**STAFF REPORT  
PLANNING & ZONING DIVISION**

Petition Number: 19 – 60 (ARB 19 – 11)

Project Name: McDonalds at Village Green Center

Request: The petitioner is seeking Architectural Review Board (ARB) approval of drive-thru digital menu board and preview menu board signs with technical deviation for the McDonalds within the Village Green Center project.

Proposed:

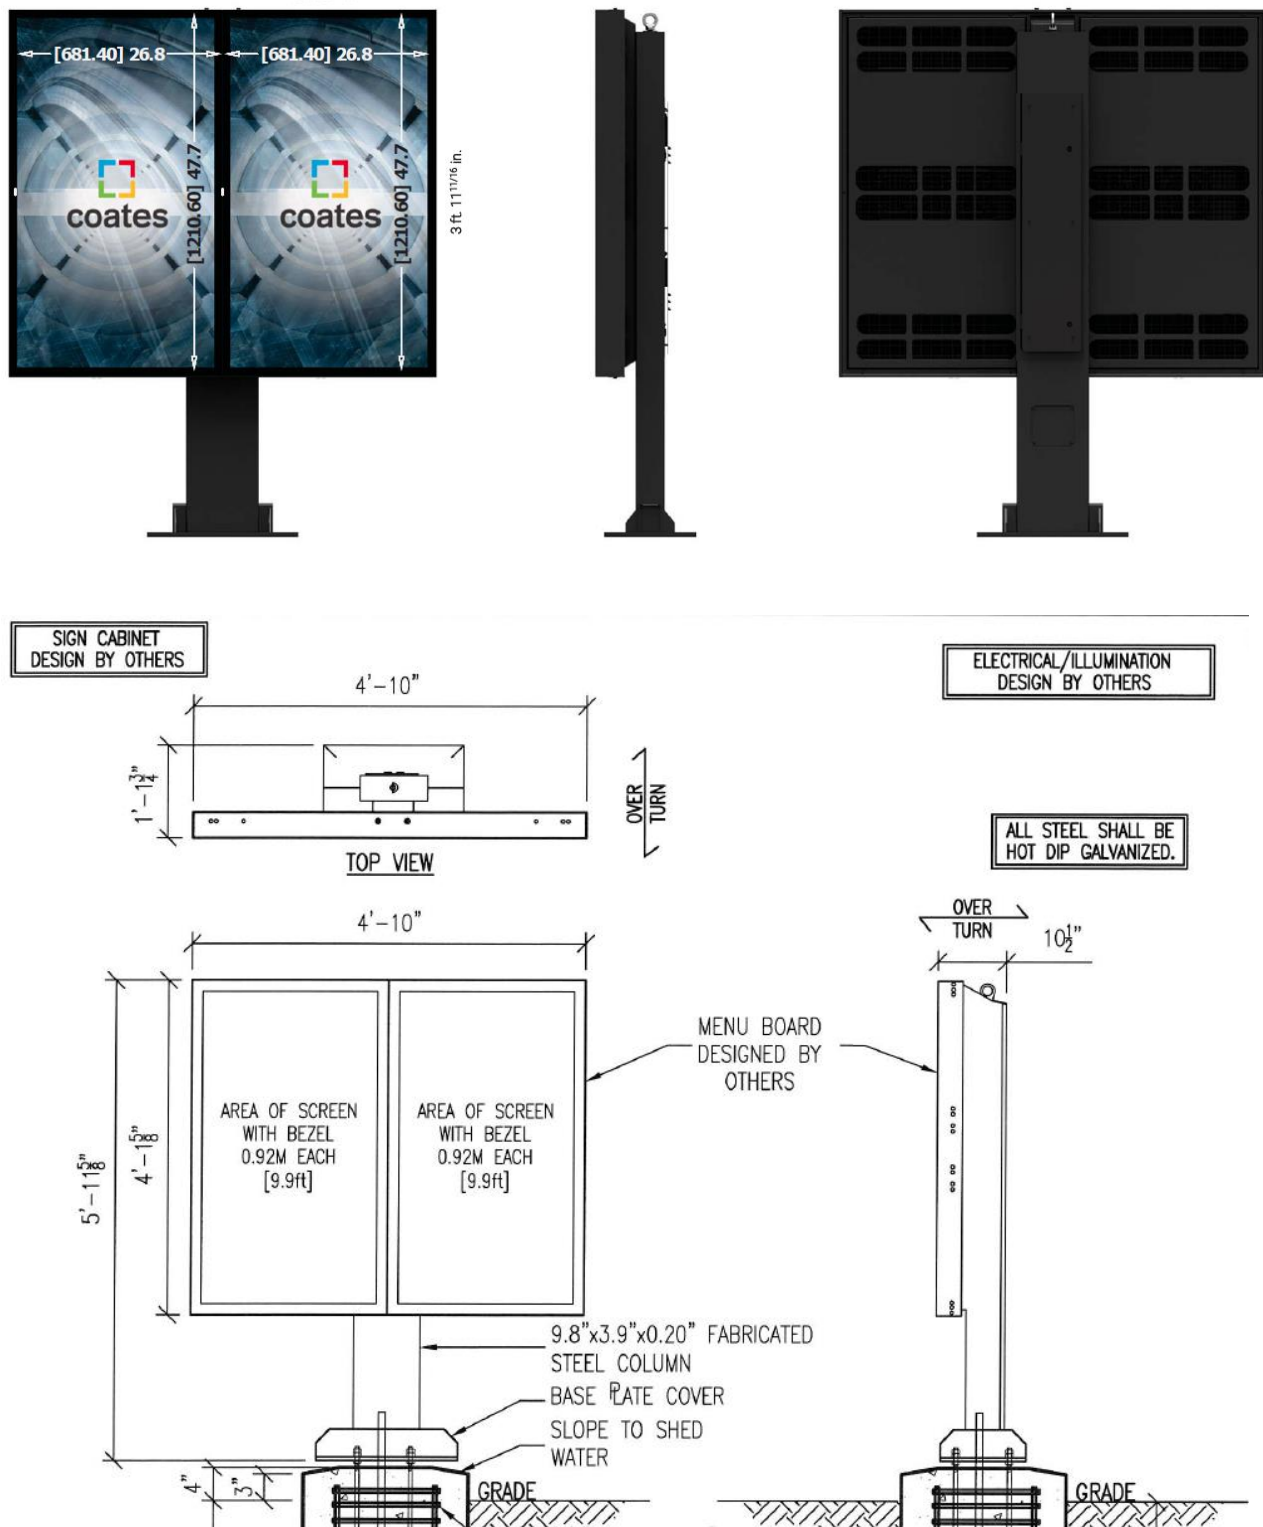
The petitioner is now seeking a height of 49 inches, length of 58 inches, sign area of 17.75 square feet and two (2) panels for the proposed two (2) digital menu board signs as illustrated below.

Drive-Through Window Signs and Section 7.14.9.C Technical Deviations. Per LDR Sec. 7.14.11. L. the signs shall not exceed four (4) feet in height, five (5) feet in length and 16 square feet in sign area.

1. The drive-thru window digital menu board sign shall be consistent with the illustration and;
  - a. Maximum Signage Area: 17.75 square feet for each sign (Technical Deviation)

- b. Maximum Sign Height: 49 inches for the sign cabinet and 5 feet 11 inches overall (Technical Deviation)
  - c. Maximum Length: 58 inches for the sign cabinet

- d. Maximum Number of Sign: 2 (1 for each drive-thru lane) (Technical Deviation)
  - e. Maximum Number of Sign Panel: 2 for each sign
  - f. Sign cabinet and column color shall be Coates dark grey (Match Pantone 446C).

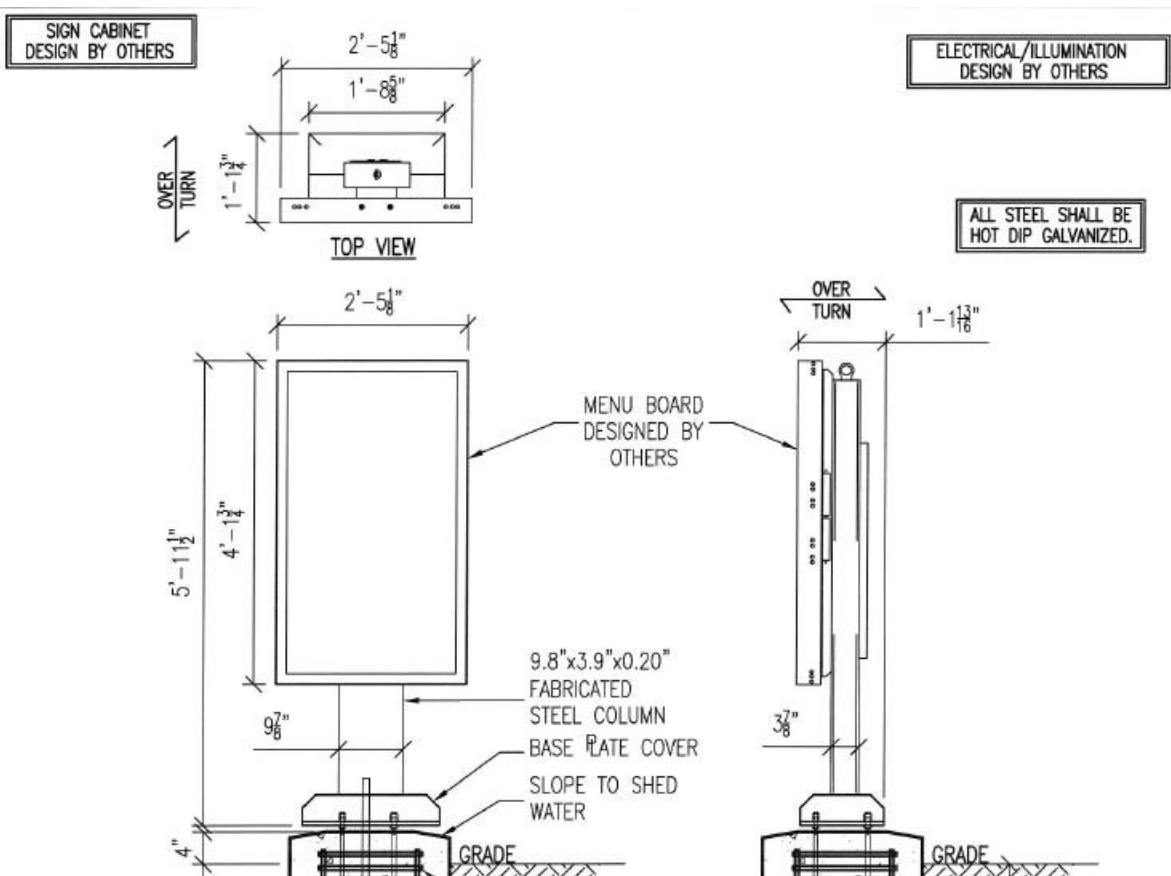
The other signs are two (2) digital "preview" menu board signs with a proposed height of 49 inches, length of 29 inches, sign area of 8.88 square feet and one (1) panel as illustrated below.

2. The drive-thru window digital “preview” menu board sign shall be consistent with the illustration and;
  - a. Maximum Signage Area: 8.88 square feet for each sign

- b. Maximum Sign Height: 49 inches for the sign cabinet and 5 feet 11 inches overall (Technical Deviation)
  - c. Maximum Length: 29 inches for the sign cabinet

- d. Maximum Number of Sign: 2 (1 for each drive-thru lane) (Technical Deviation)
  - e. Maximum Number of Sign Panel: 1 for each sign
  - f. Sign cabinet and column color shall be Coates dark grey (Match Pantone 446C).
